## PROTECTA SHOCK ABSORBING LANYARDS

### RECALL NOTICE

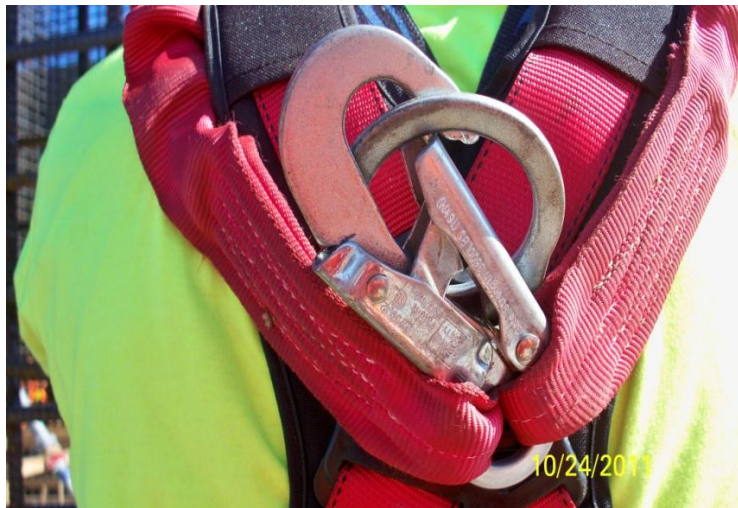
In a particular configuration when the twin lanyard legs are pulled upwards simultaneously and the snaphook gets compressed against the d-ring, the combination of forces acting on both the locking mechanism and the gate opening of the snaphook may cause the snaphook to disconnect from the d-ring. (See photo below)

The identified reason for the inadvertent disconnection is the combination of a particular style locking snaphook together with twin elastic lanyard legs attached directly to the eye of the snaphook. Although there have been no reported falls or injuries associated with the use of this configuration lanyard, CS is committed to the safety of every worker at height using our products and we are determined to resolve any potential for inadvertent disconnection to occur for the reason described above.

Capital Safety has determined that the appropriate solution to the identified issue is a combination of (a) an alternate snaphook and (b) a single lanyard connection to the eye of the snaphook. Accordingly, we have engineered a new version of the affected lanyards to take into account what we have learned about the combination of components on the Protecta shock-absorbing lanyards.
